PLANNING COMMISSION STAFF REPORT

Petition No. 410-07-31 Diamond Parking North Temple Conditional Use Located Approximately at 1925 West North Temple Street.

Public Hearing Date: April 9, 2008

**DAMOND PARKING NORTH TEMPLE
 CONCEPTUAL SITE PLAN**
 SALT LAKE CITY, UTAH

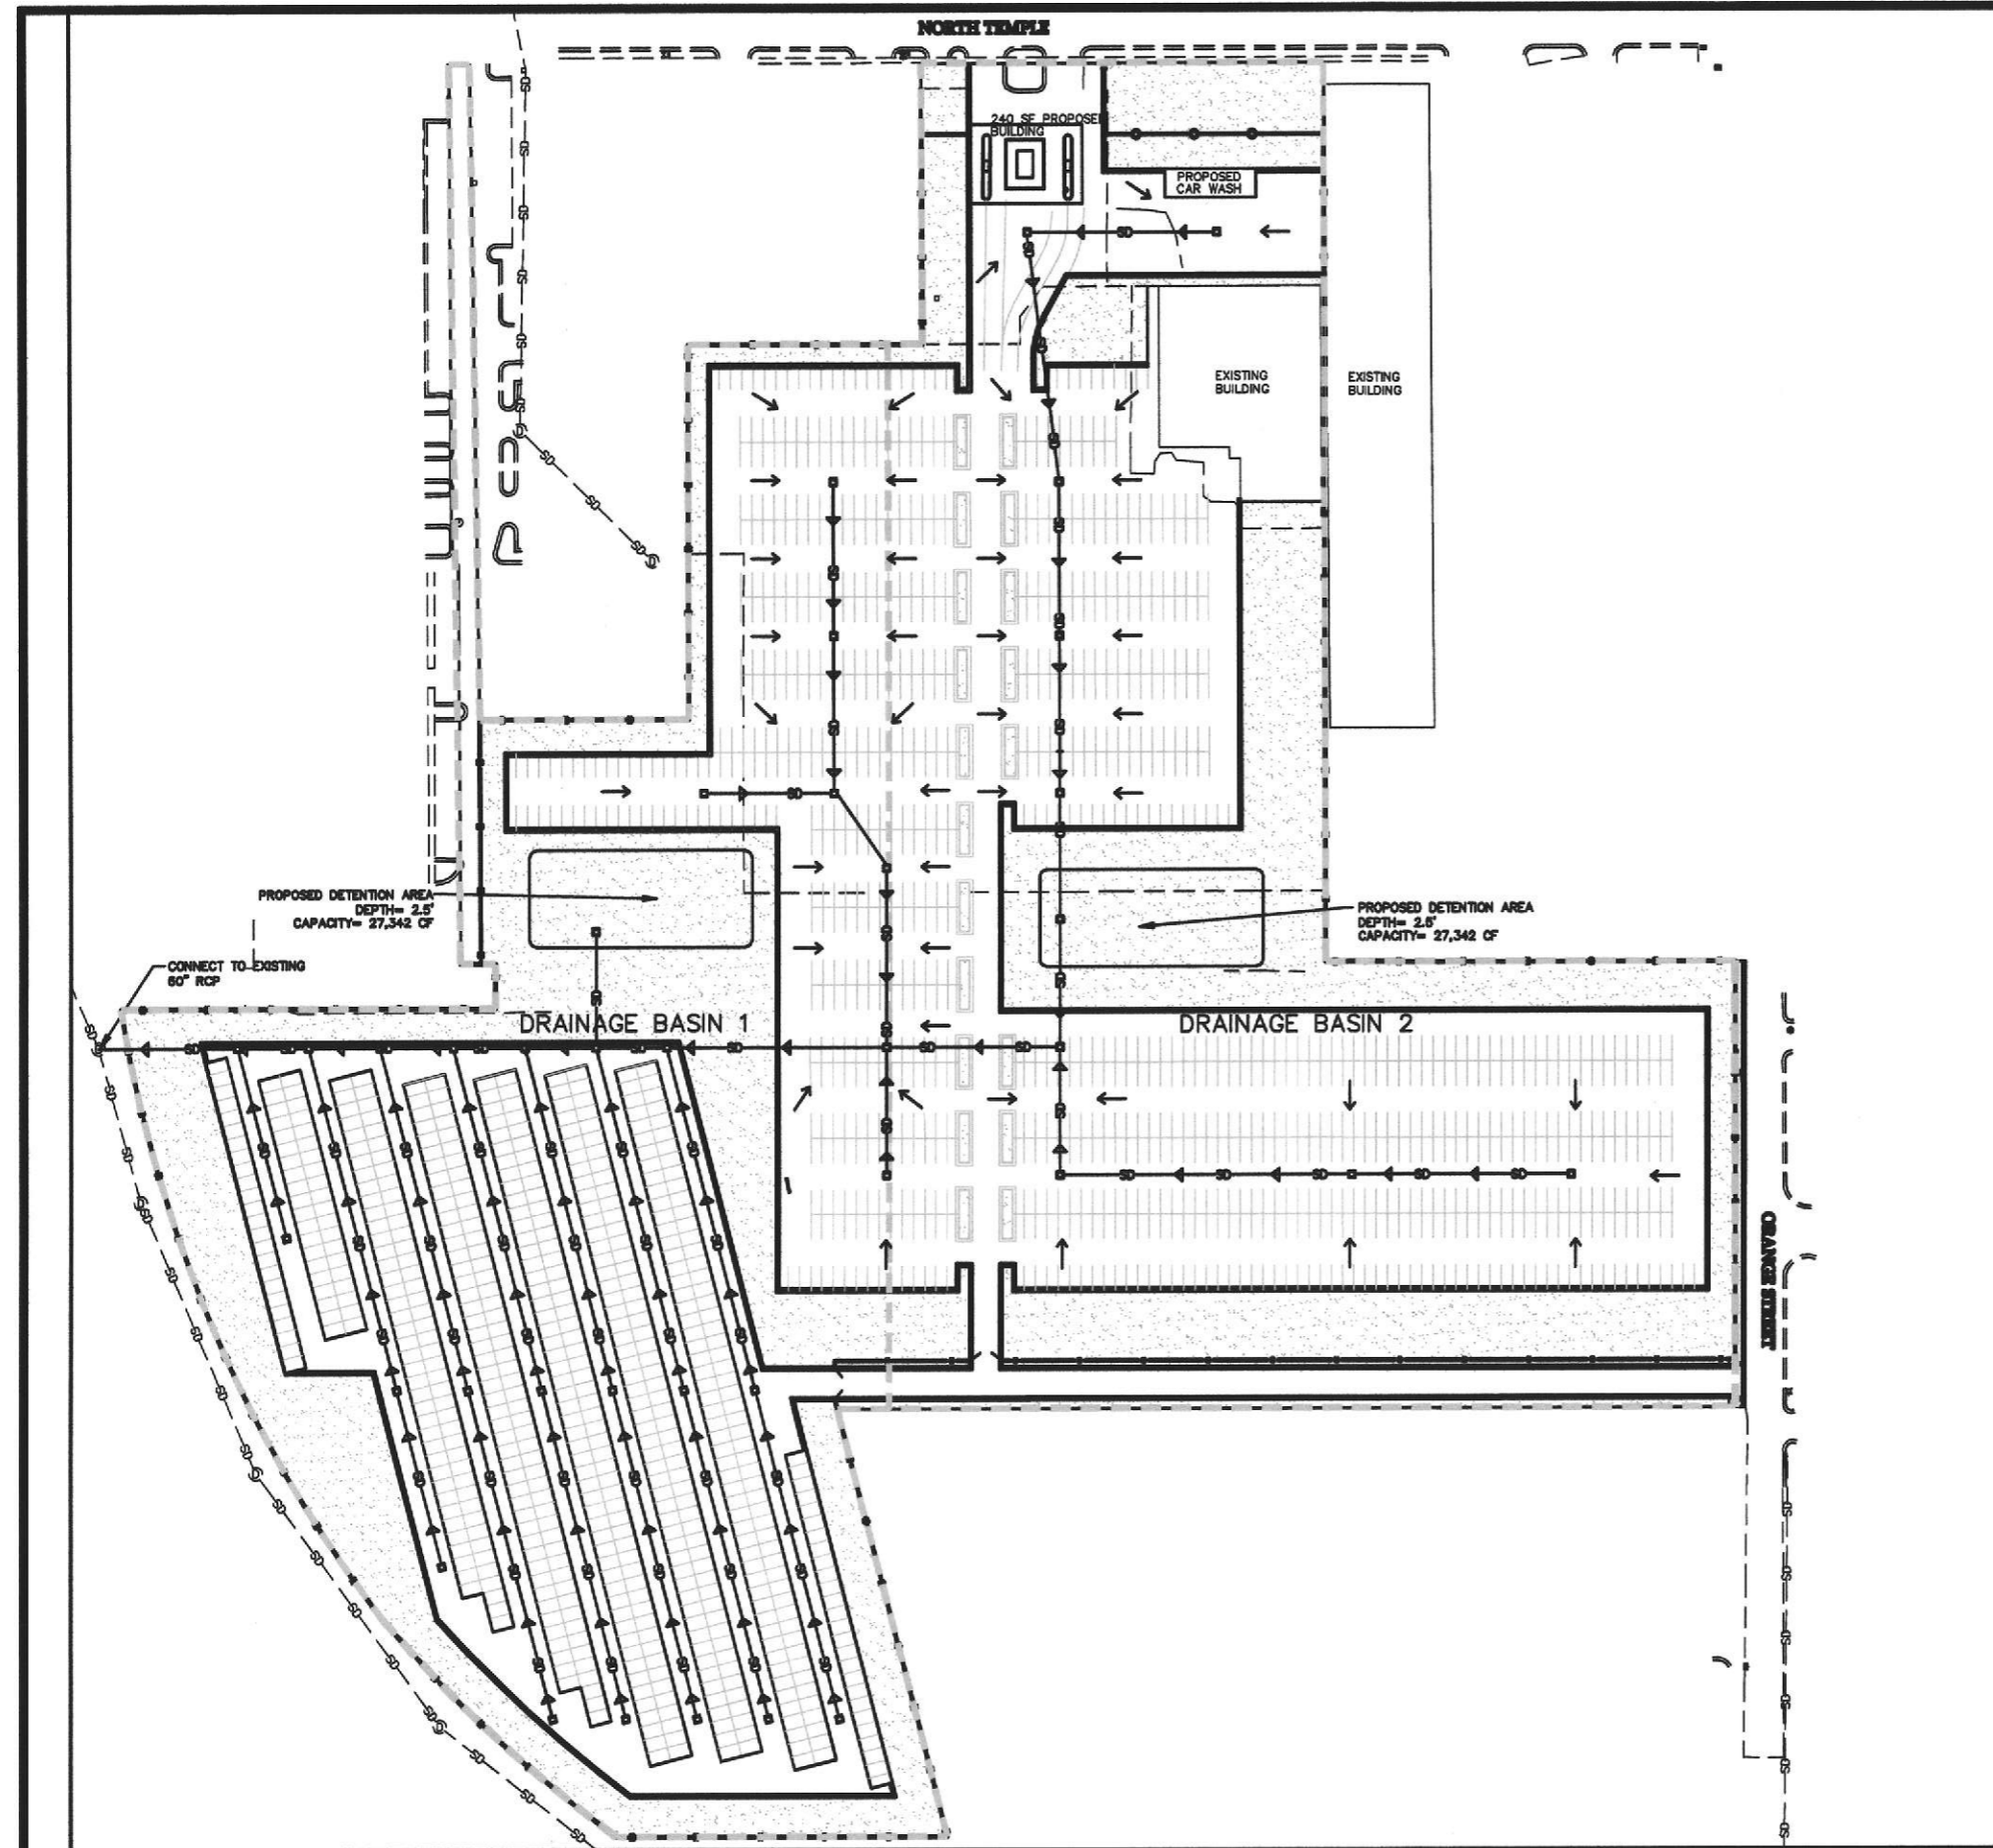
Per Our DRT review on 06/13/07 for Diamond Parking & RV Storage proposal our review comments indicated that UDOT review for dead driveways and access along North Temple is required. We also need clarification of right of way. The new development needs to align with existing approaches or relocated approaches.

We noted the ADA & 5% Bike parking for required parking. The parking shown (18.5'x 8.5' stall and 21' isle) does not comply with Salt Lake City Corporation design standards. The circulation needs to be reviewed by Fire for access isle widths and turning radii for the storage unit area. A pedestrian sidewalk corridor is needed from the public way for parking lots over 30 stalls.

The plan shown raises questions about the existing access and circulation to abutting properties to the west (1975 West) etc.
